Service Information

Category S	Repair Guidance	Ref. No. R077/12A	Page 1 of 3
Coverage <input type="checkbox"/> Distributor only <input checked="" type="checkbox"/> Please inform your dealers		Date Issued October 30, 2012	
Please convey this information to your <input type="checkbox"/> Director <input checked="" type="checkbox"/> General Manager <input checked="" type="checkbox"/> Warranty Dept. <input checked="" type="checkbox"/> Parts Dept. <input checked="" type="checkbox"/> Training Dept. <input checked="" type="checkbox"/> Field Rep.		Date Revised September 30, 2013	
Applicable Model CX-5 (KE) with 4:2:4 split-type rear seat	Applicable Countries or Specifications Worldwide

Subject: Unable to Fold Rear Seatback by Remote Handle Lever, or Difficult to lock them

<Case 2>

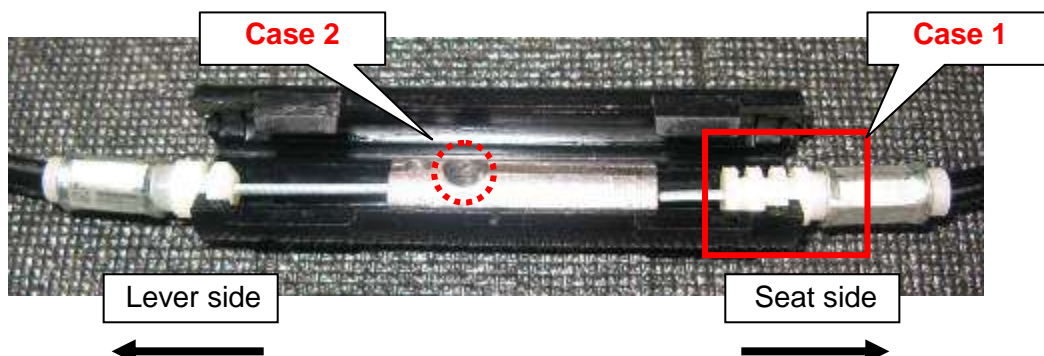
The cable ball gets seized on sharp edges inside the cylinder.

The sharp edges have been finished to round shape.

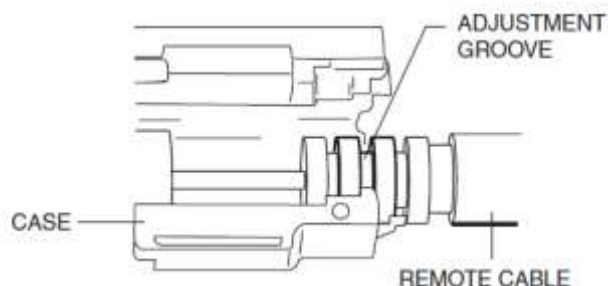
- Set the adjustment groove to the position where the malfunction does not occur. (The below figure shows as a sample that it is adjusted to the center position.)
